The enclosed Defense Nuclear Facilities Safety Board Technical Report is provided for your information and use. It provides an analysis of the Department of Energy's proposed control strategies to address safety issues associated with flammable gas and criticality hazards in the Pretreatment Facility at the Waste Treatment and Immobilization Plant.

**FLAMMABLE GAS AND CRITICALITY HAZARDS  
AT THE WASTE TREATMENT AND  
IMMOBILIZATION PLANT**

**Defense Nuclear Facilities Safety Board  
Technical Report**

**June 2017**

**Figure 3.1.** *Unmixed regions in the sparge heel and PJMs from the ZOI/CAD model for the HSLs mixing system (adapted from Appendix B of [20]).*

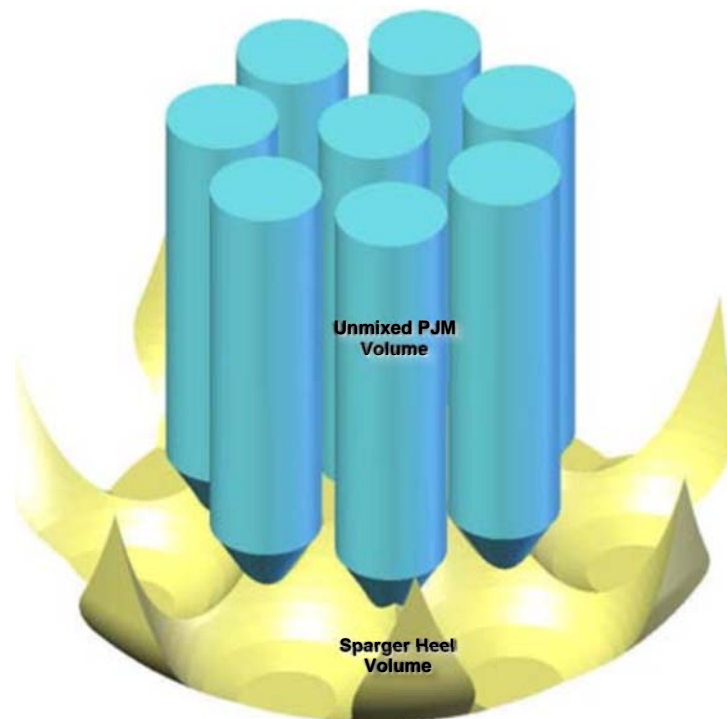
The Board also notes that the relationship between the actual sparge heel volume and the volume computed using the ZOI/CAD method may not be the same for the HSLs and SHSV designs. Differences in vessel geometry, PJM layout, the number of sparge tubes, individual sparger air flowrates, and test vessel scales could potentially influence the relationship. Further, the SHSV must also operate in the high-solids Newtonian regime. The previous HSLs testing did not include sparge heel measurements with high-solids Newtonian simulants. Hence, these tests do not provide an adequate technical basis for determining the sparge heel in the SHSV for high-solids Newtonian conditions.

Measuring the sparge heel in the SHSV during the full-scale test program could eliminate the significant uncertainties discussed above and establish a conservative value for the sparge heel volume. Methods similar to those used previously in the HSLs program, such as the chloride tracer technique, could provide sufficient information to accurately determine the volume of the sparge heel.

**Figure 3.2.** Calculated solids loading in the settling solids layer in the FRP-02 vessels as a function of solids layer height. Shown also for comparison are three of the high-solids vessels using the SHSV design.

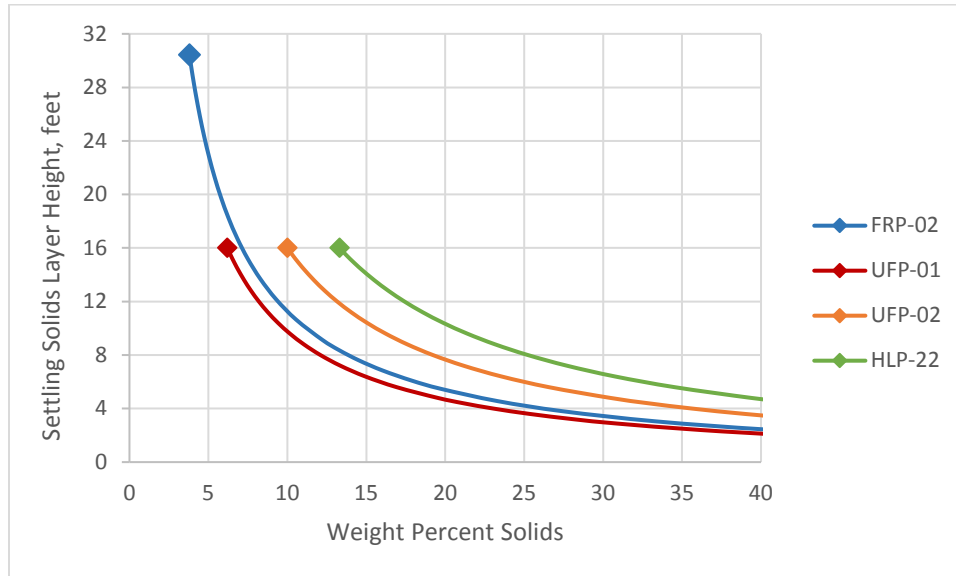
BNI documented the technical basis for the SAC on vessel level in Appendix K of the engineering study [15]. The BNI analysis models gas generation and build-up in a settling solids layer, and calculates the time to accumulate sufficient hydrogen in the solids layer to reach the LFL in the headspace for the instantaneous release of hydrogen. The analysis contains several modeling assumptions that may be non-conservative. In particular, the Board notes three areas where the analysis may be non-conservative:

- The BNI analysis assumes the solids settle to a thin layer, which may not represent the conservative case for total hydrogen generated.
- The BNI analysis assumes the solids layer settles exponentially, and that most of the settling occurs in the first 300–400 hours. A slower settling rate would provide more time for hydrogen to be generated and retained as the solids layer settles.
- The BNI analysis assumed the unit hydrogen generation rate (UHGR) varied linearly between the value reported in the WAC [10] for the fully mixed vessel and a higher value derived from a heat transfer analysis for a stationary solids layer [17]. This may not be conservative based on the spatially and temporally changing solids distribution and the evolving heat transfer boundary conditions.

**Figure 3.3.** UHGR at 1,000 hours versus settling fraction from the Board's calculations (Appendix B) and the linear assumption used in Appendix K of [15].

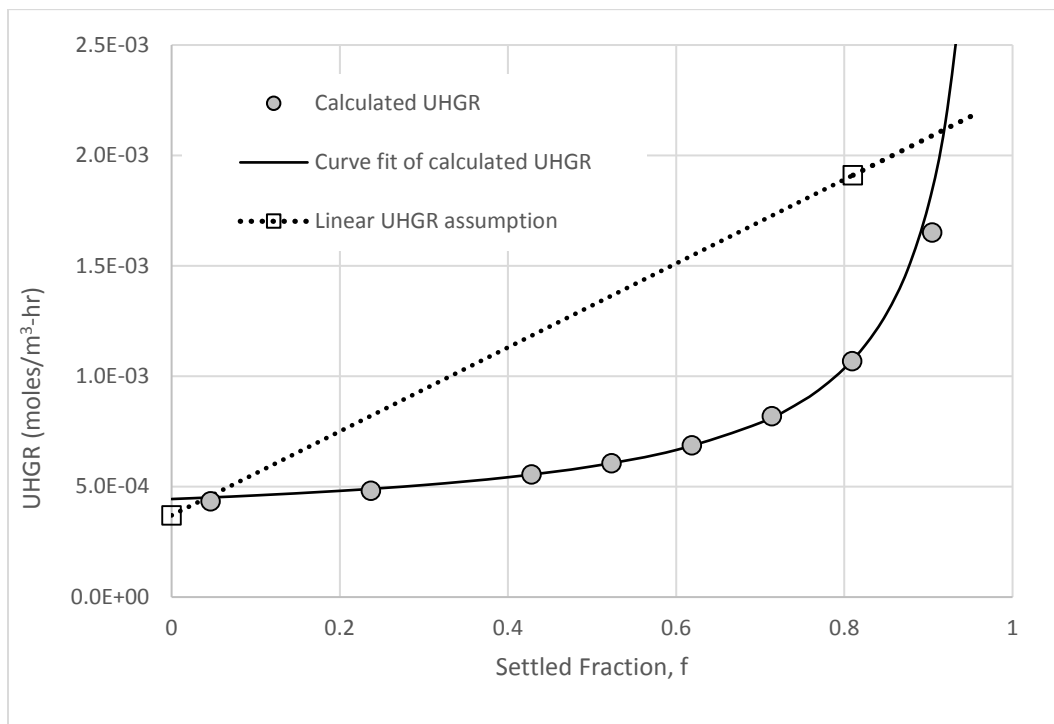
Figure 3.3 shows the results for our calculated UHGR at 1,000 hours as a function of the settled fraction. The Board obtained these results by curve-fitting the calculated UHGR values. The Board’s model assumes the UHGR is only a function of the settled fraction (i.e., it is not a function of time). This assumption is conservative because it uses the final UHGR at 1,000 hours for each intermediate settling fraction throughout the settling process. This assumption is discussed further below. Figure 3.3 also shows the linear UHGR assumption employed in Appendix K of the engineering study [15]. The Board analysis incorporated both the calculated UHGR and the linear UHGR assumption.

The Board calculated the retained gas fraction in the settled solids layer after 1,000 hours. The total gas retained is the combination of hydrogen and other gases. The Board compared the retained gas fraction with the stability criteria for two different spontaneous release mechanisms: bubble cascade and buoyant displacement gas release. Bubble cascade gas release occurs in weak sludges and depends on the local yield stress. The buoyant displacement gas release requires a stratified layer and occurs when the bulk density of the lower solids layer reaches that of the liquid above it. The Board's analysis indicated that for most conditions, one or both of the stability criteria for gas release were exceeded. The main factor affecting stability is the amount of generated non-hydrogen gas. Samples from Hanford waste tanks demonstrate the fraction of non-hydrogen gas varies considerably (Appendix H of [15]). A large non-hydrogen gas fraction results in a significant amount of total retained gas. This retained gas exceeds the stability limits for spontaneous gas releases during settling in the FRP-VSL-00002A/B/C/D vessels.

**Figure 4.1.** The solubility of sodium pentaborate at 298 K reported by Yongquan et al. [50] (blue squares) and by the WTP CSE-ES [30] (solid black line and red circles).

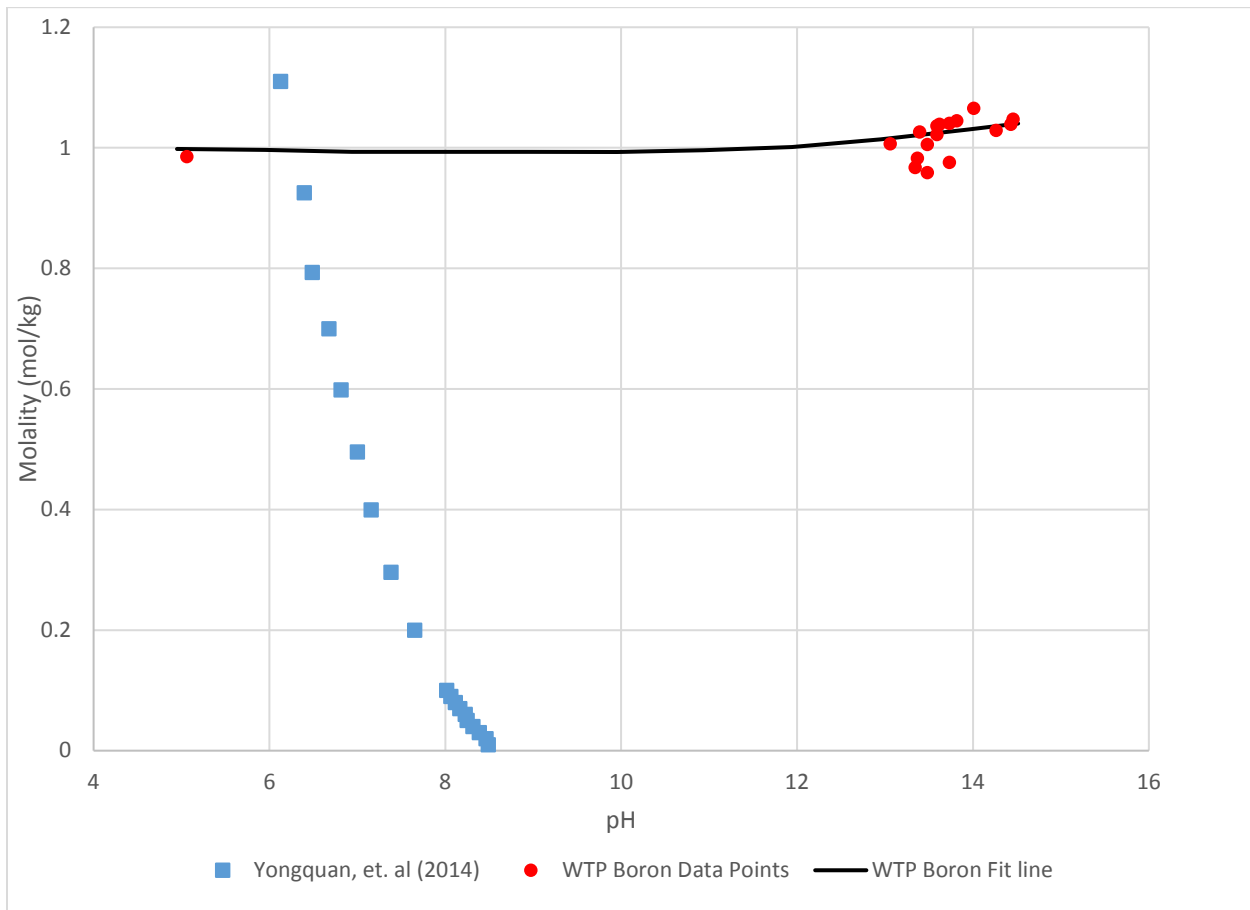
The Board also found the boron solubility used in the CSE-ES is inconsistent with solubility data available in literature [50]. The CSE-ES assumes that SPB, once introduced to WTP facilities, will exhibit the same solubility behavior as boron already present in the waste (Figure 4.1, black line). The CSE-ES also acknowledges that boron solubility needs to be

confirmed for the waste conditions in WTP. Figure 4.1 shows the CSE-ES boron solubility data and curve fit (represented by red dots and a black line) and the Yongquan et al. SPB solubility data [50] (represented by blue squares).

The boron solubility from the CSE-ES is relatively constant over a broad pH range. However, SPB solubility reported by Yongquan et al. shows a strong SPB concentration dependence on pH. Also, the CSE-ES does not specify the chemical composition of boron used to derive the data. Therefore, the assumption made by the CSE-ES that boron and SPB have the same solubility may be incorrect. [Note: The original solubility curve for boron in the CSE-ES is represented in units of molarity (mol/L), whereas the solubility data reported by Yongquan et al. is in units of molality. To provide an accurate comparison of the solubility curves for both boron and SPB (Figure 4.1), the Board converted the molarity of boron to molality using the theoretical density of 1 g/cm<sup>3</sup> for water.]
